City of Dublin
Land Use and
Long Range Planning

Development Context
August 21, 2008

08-065AFDP
Amended Final Development Plan
Heather Glen Village-Three Season Room
Glenvillage Drive

THREE SEASON ROOM ELEVATIONS

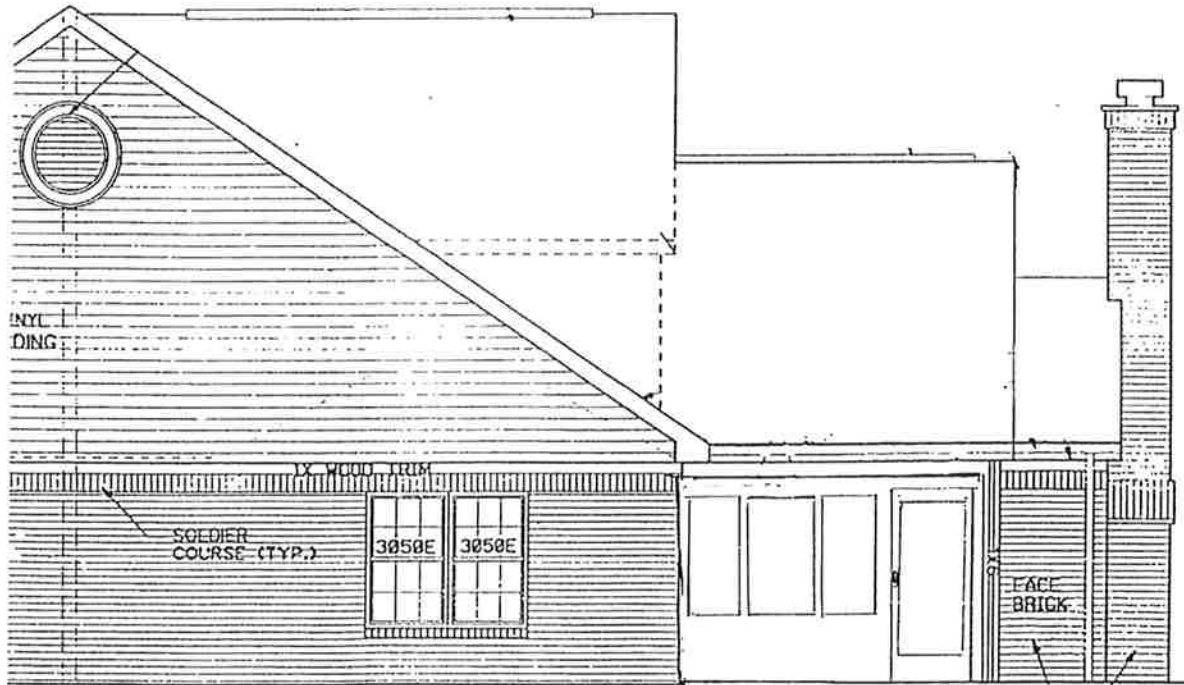
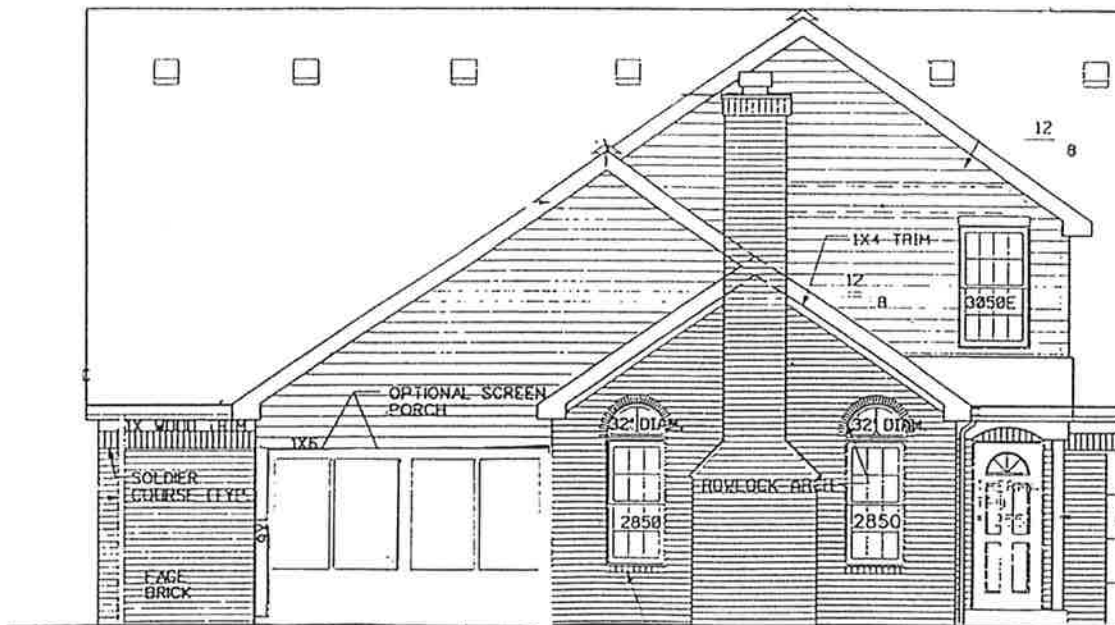
The proposed materials will consist of wood and siding to match the existing siding, and have divided windows, screens, and doors with either full glass or glass panels above and solid below. These materials will be consistent throughout and will match the primary buildings.

Criteria met: The proposal conforms to the preliminary development plan requirement for appropriate landscaping details, and provides adequate stormwater management. The proposed materials and patio details complement the existing buildings.
